GISBORNE WASTEWATER NETWORK – OVERFLOW DISCHARGES: REGULATORY REF: DW-2020-109732-00/WD-2020-109733-00

Further S92 Response 21 April 2021

1401_ORMDSM125\mp1\QFINAL
1401_RG2\mp1\RAIN

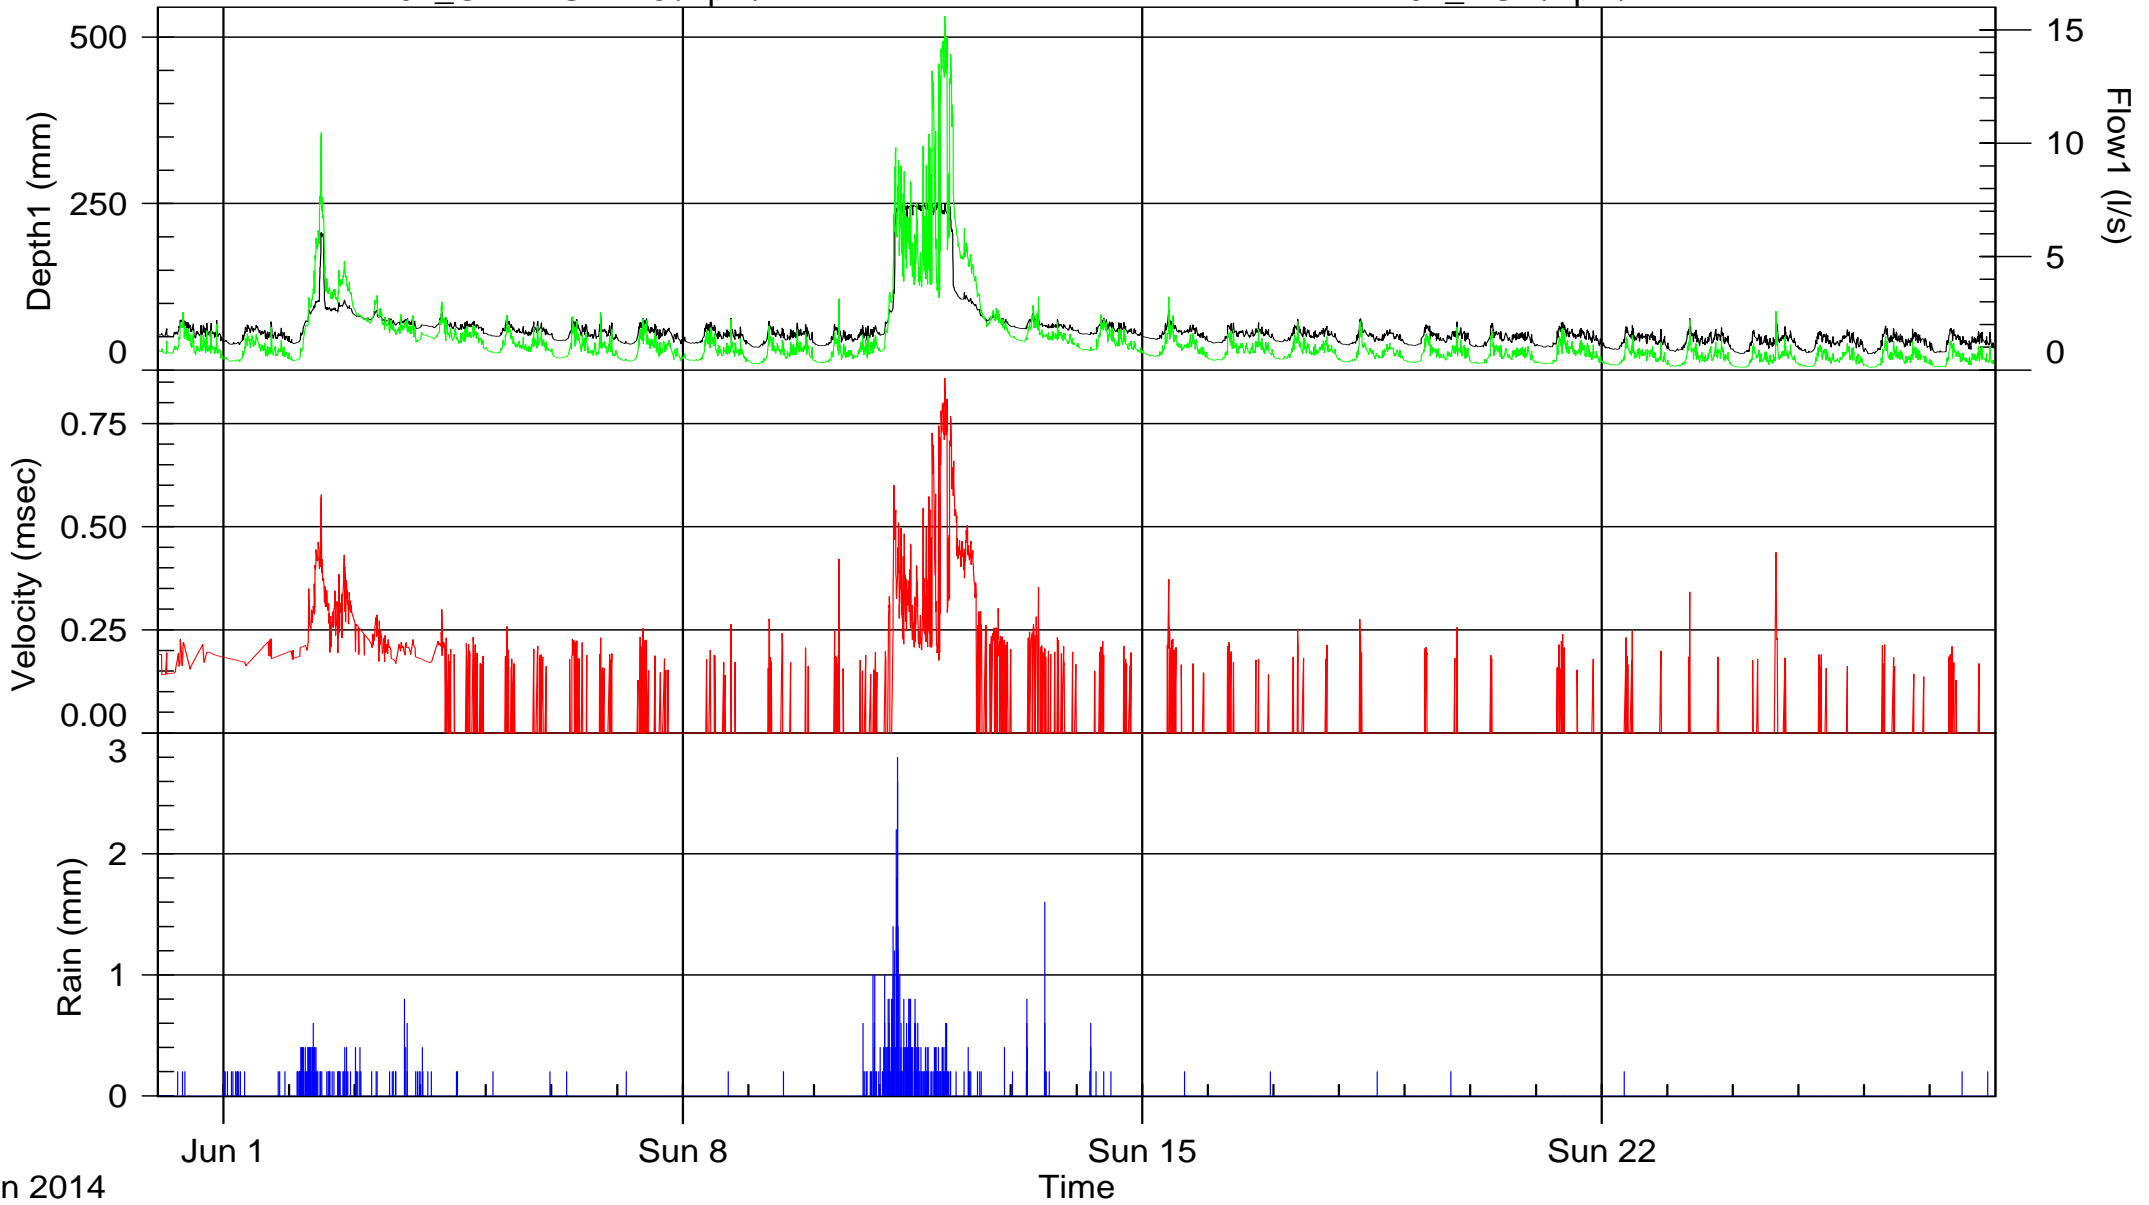
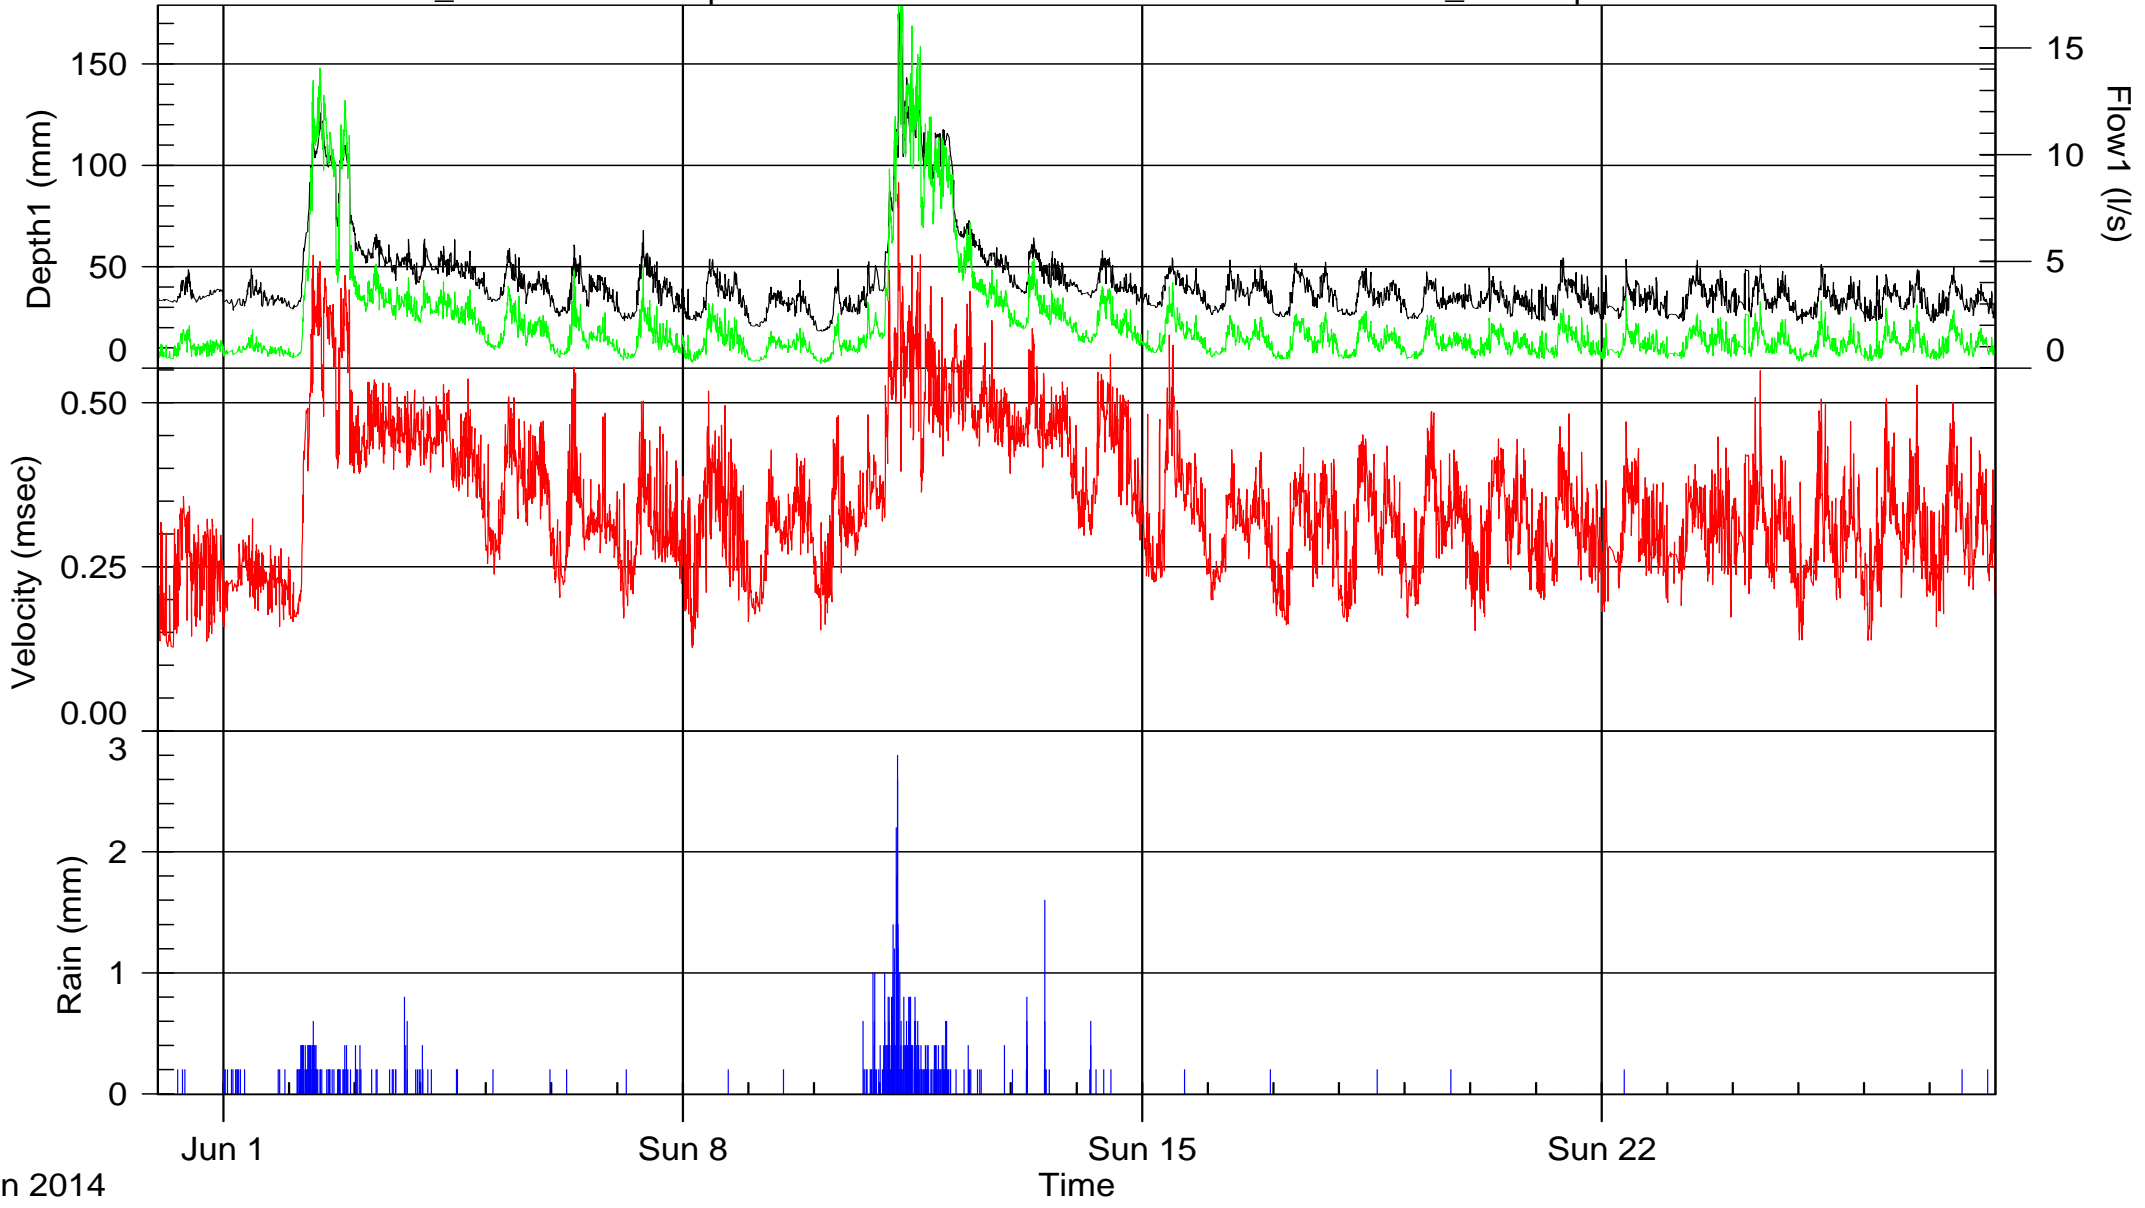
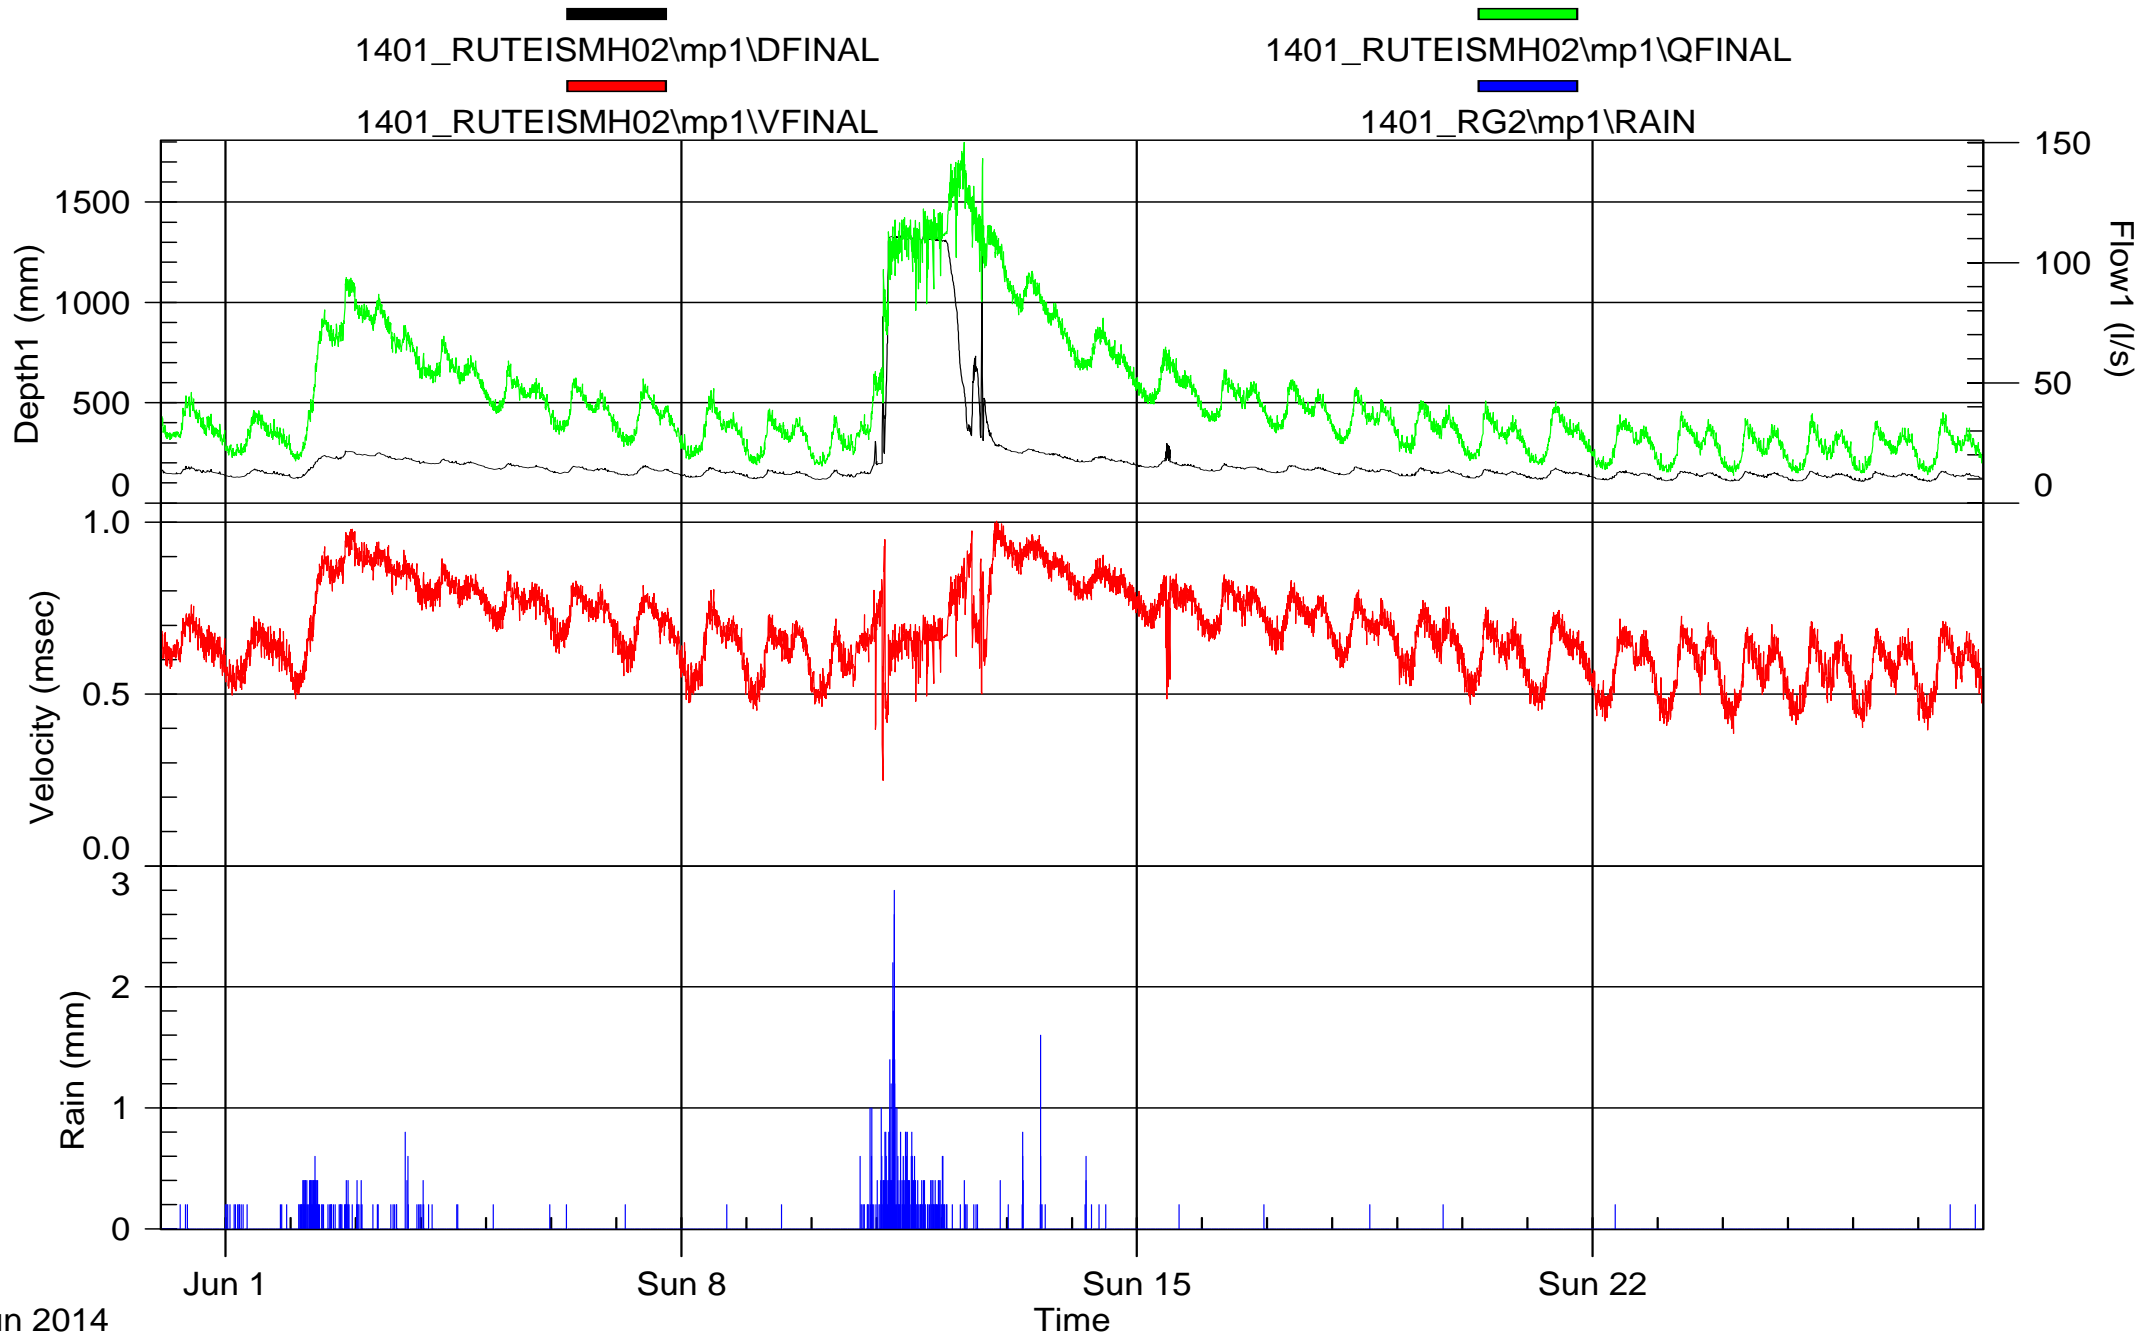
<p>upstream wastewater network including pump stations and reference (from the Mott Macdonald gauging report) which locations/hydrographs one(s) show the fast response to direct inflow?</p>	<p>We have also extracted flow monitoring information from the Mott Macdonald report for June 2014 (Attachment B) to facilitate review of the network flow monitoring across the monitoring sites. As can be seen from this extract, all of the monitoring sites show rapid response to heavy rainfall. Some sites to the south of the Taruheru River (eg APNISM135, DISRSM125 and LYTTSM075) also show the influence of overflow valves being opened from 11 to 12 June 2014.</p>
<p>b. Can the applicant provide a map/schematic that show areas of known property flooding referenced in the original application, page 223, see Figure 3-2 from the CH2M Beca Modelling Report, 2017. How does this compare to the nodes identified as flooding in the 2yr-ARI map (Figure B2) in the Beca modelling report.</p>	<p>A map showing indicative property ponding is provided below.</p> <p>The 'Ponding Likelihood' layer predicts where water is likely to pond on a property, based on a number of GIS layers that have been aggregated through a weighting process. These GIS layers include our stormwater flood model, depressions layer, and a Rain on Grid model.</p> <p>Ponding can be affected by many factors, e.g. fences on a property may divert flows, private stormwater sumps and pipes may drain areas, and soil conditions may allow for water to seep into the soil quicker than modelled. The data is also relevant to information available at a specific point in time, and things may have changed over time. Therefore, this layer is viewed as a guide only, as site conditions could be different.</p> <p>The modelled information is based on geospatial modelling, is for indicative purposes only. Council also uses records of actual flooding (surveys and Requests for Service received) and undertakes property inspections / investigations to validate whether or not there are actual effects, and whether or not stormwater drainage improvements (public or private) are required to mitigate the risk of ponding.</p> <p>The nodes identified in Figure B2 have been overlain on the Ponding Likelihood' layer. However, the location of property flooding in heavy rainfall will not necessarily correlate to the location of wastewater overflows from manholes.</p> <p>While property flooding is considered a primary cause of rainwater entering the wastewater system, properties that experience wastewater overflows will not necessarily also be the properties that experience rainwater flooding. Property</p>

<p>c. Can the applicant please provide a <u>model calibration report</u>. This should include a comparison between predicted/modelled flows and gauged data and demonstrate how well the model performs. This is required to determine the level of confidence in the modelling results (and subsequent conclusions).</p>	<p>No specific calibration report was produced. The flow gauge data and model graphs were part of the calibration process as is standard practice. The model aims to reflect the AWT flow gauging report that shows rainfall and the resultant wastewater flows that occur very quickly afterwards. As indicated in our previous response, the flow gauging sites were selected with a key aim of calibrating the model to predict overflow performance. The flow records show rapid and substantial increases in wastewater network flows associated with rainfall events and this is a clear demonstration of the result of direct stormwater inflow (Fast Response), which is replicated in the wastewater model.</p>
